Subject: Final Shiprock Ground Water Compliance Action Plan

Two copies of the final *Ground Water Compliance Action Plan (GCAP) for Remediation at the Shiprock, New Mexico, UMTRA Site*, dated July 2002, are enclosed.

## Responses to Navajo UMTRA and Knight Piesold Comments and U.S. Fish and Wildlife Service Comments on the February 2002 Shiprock Draft Ground Water Compliance Action Plan

# Final Ground Water Compliance Action Plan for Remediation at the Shiprock, New Mexico, UMTRA Site

Figure 2-2. Shiprock Site and Surrounding Area

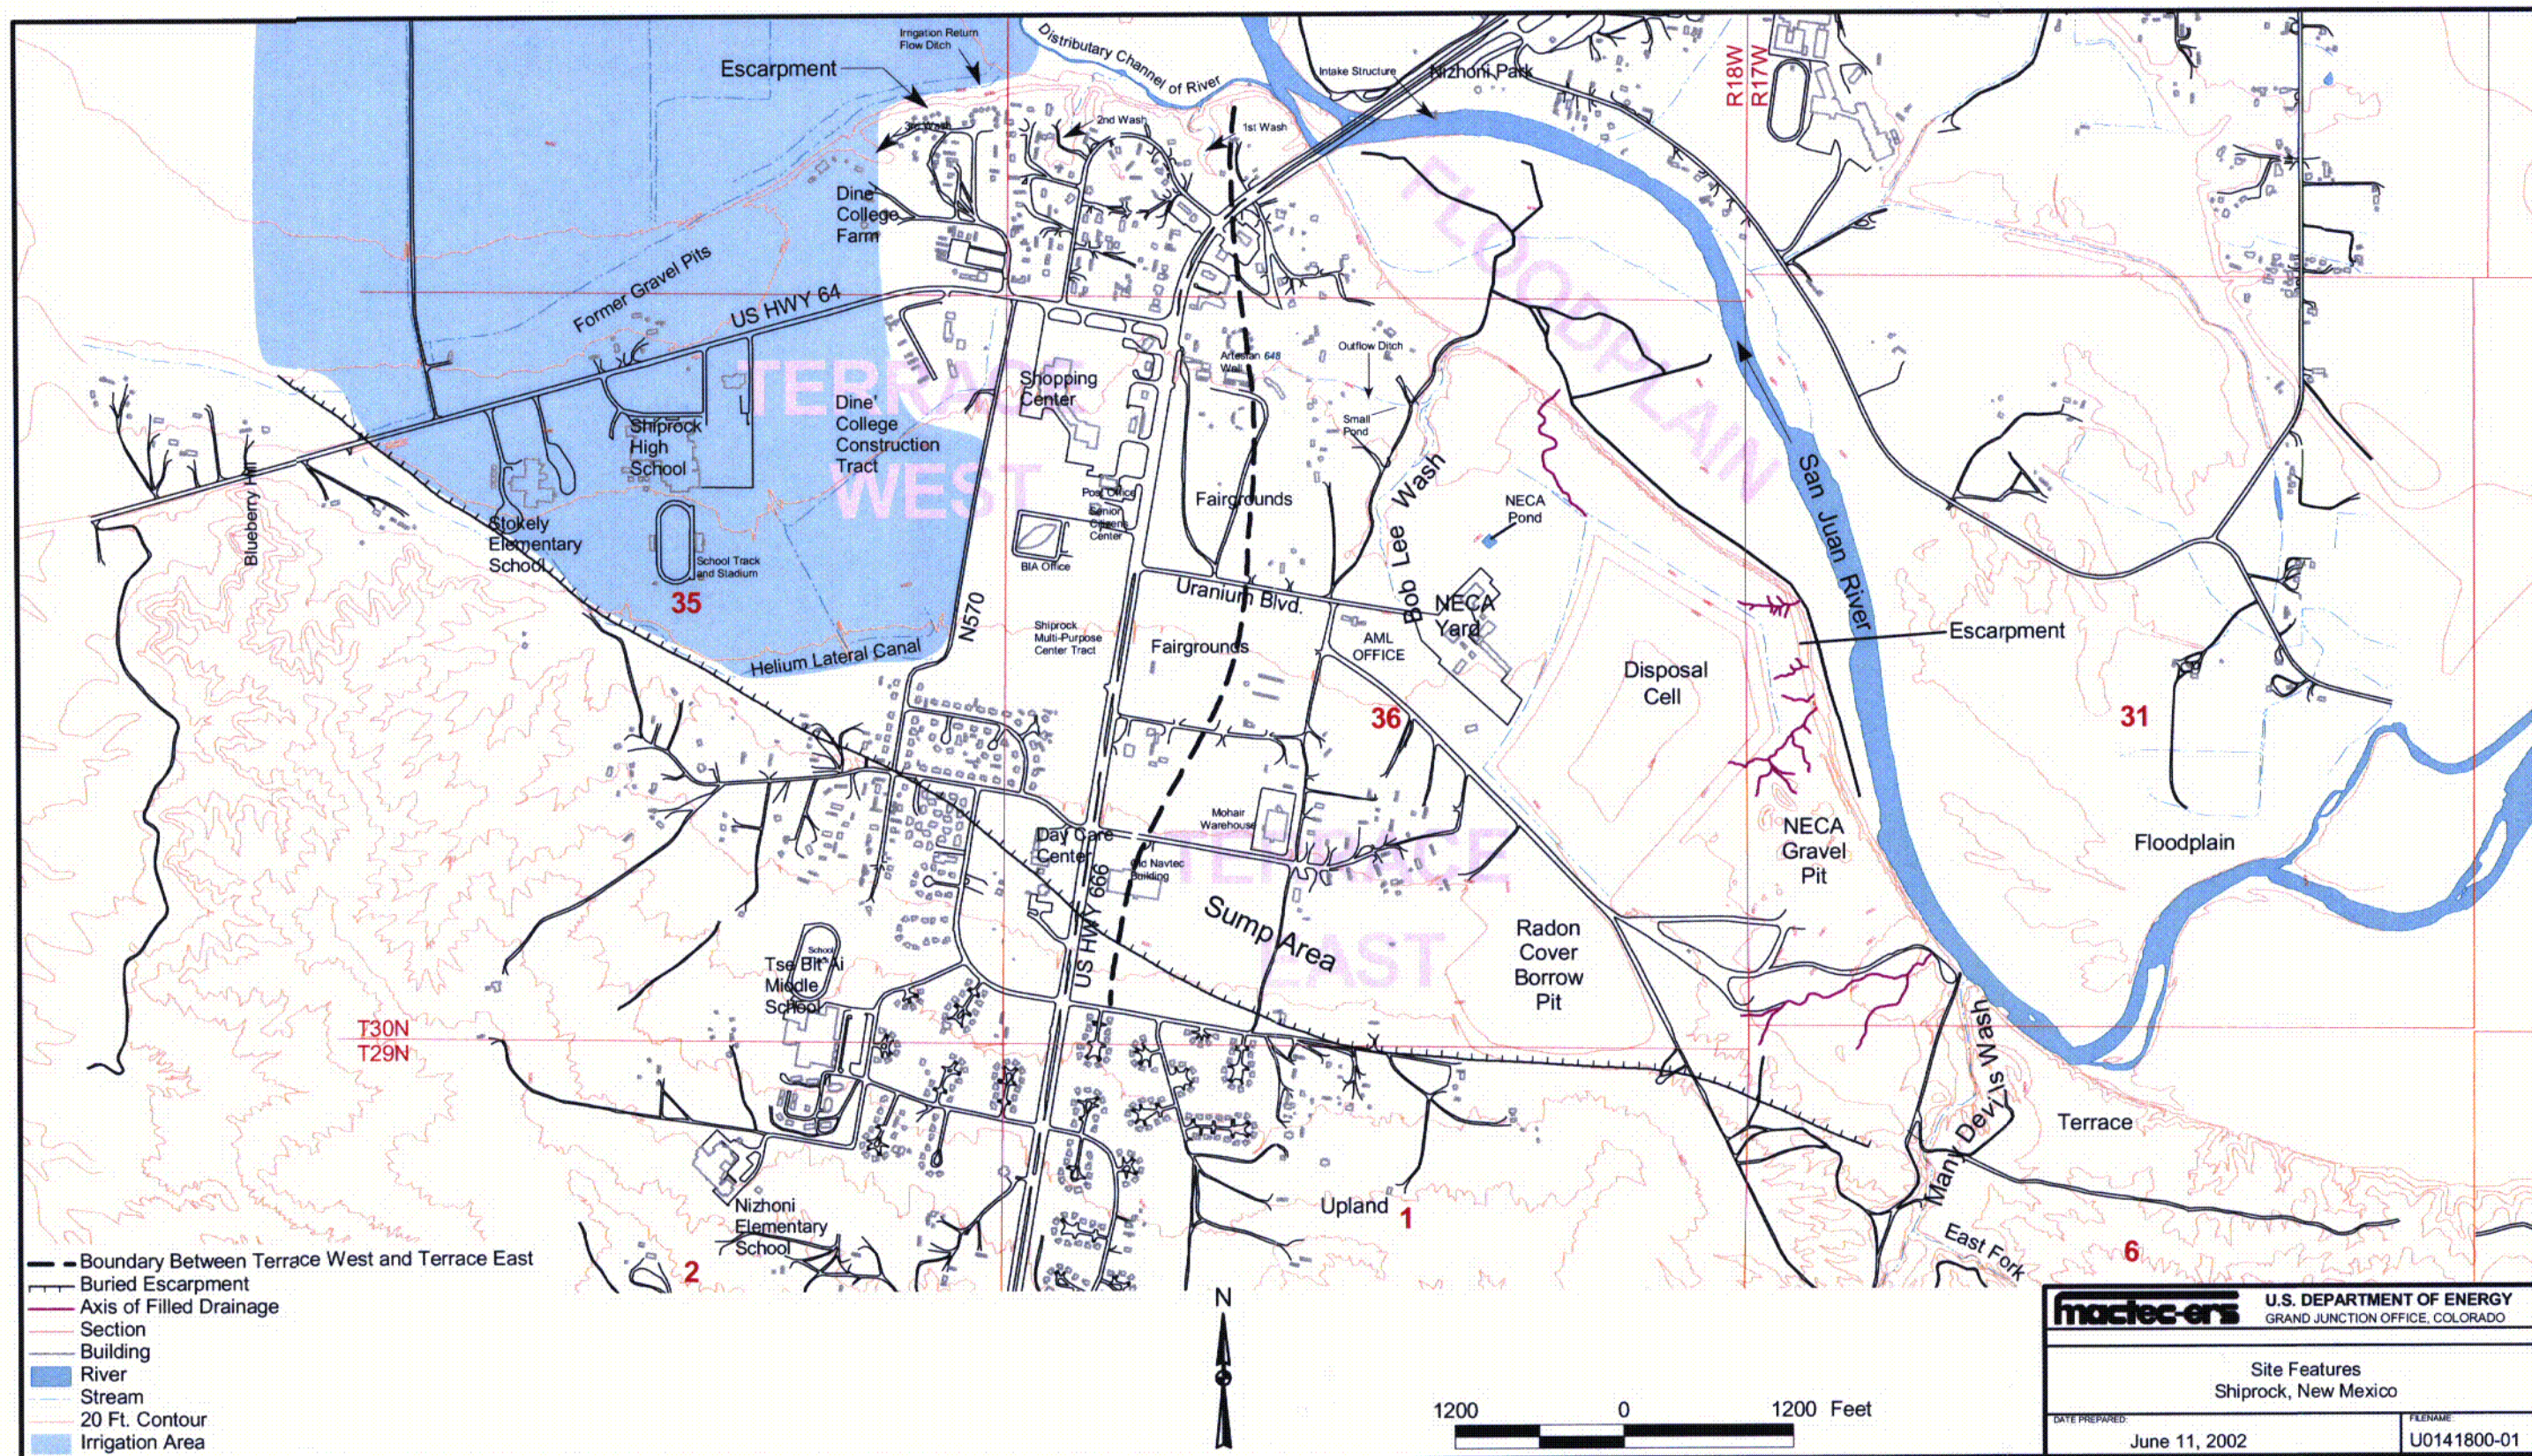
U.S. Fish and Wildlife Service Comments <sup>a</sup>	Response/Resolution
	<b>General Comments</b>	
1	The terrace west area has been omitted from the ground water remedial strategy and will likely represent a continuing source of contaminated water to springs and the distributary channel. The USFWS disagrees with the statement in the GCAP, last sentence of p. 3-4, that "Neither the milling-related nor natural contamination leaching from the Mancos Shale poses an excessive risk to humans or wildlife at this time" and encourages the DOE to re-evaluate its ground water remediation strategy for terrace west. A remedial method should be developed that prevents surface expression of contaminated ground water and subsequent potential adverse effects to listed species and migratory birds.	Terrace west has not been omitted from the ground water remedial strategy. Terrace west and terrace east ground water systems are presently connected. Extraction of ground water from the sump area of terrace east should result in lowering of water levels in the downgradient terrace west area. Planned monitoring of water levels in terrace west wells will track the effectiveness of this strategy; if water levels do not decrease after 2 years, then a decision will be made whether to install additional extraction wells in terrace west. Extraction of ground water from terrace east should also result in decreasing the amount of water flowing from seeps in 1st and 2nd Washes. Planned monitoring and sampling will also document these decreased flows and contaminant concentrations; if the decreases don't occur, then interim actions will be considered. The last sentence on p. 3-4 in the draft GCAP was deleted.

After extracting ground water in the sump area in the terrace east system for a period of approximately 7 years, the terrace east system will be cut off from the terrace west system. As determined by modeling, the approximate boundary between the two systems after this period is shown in Figure 2-2.
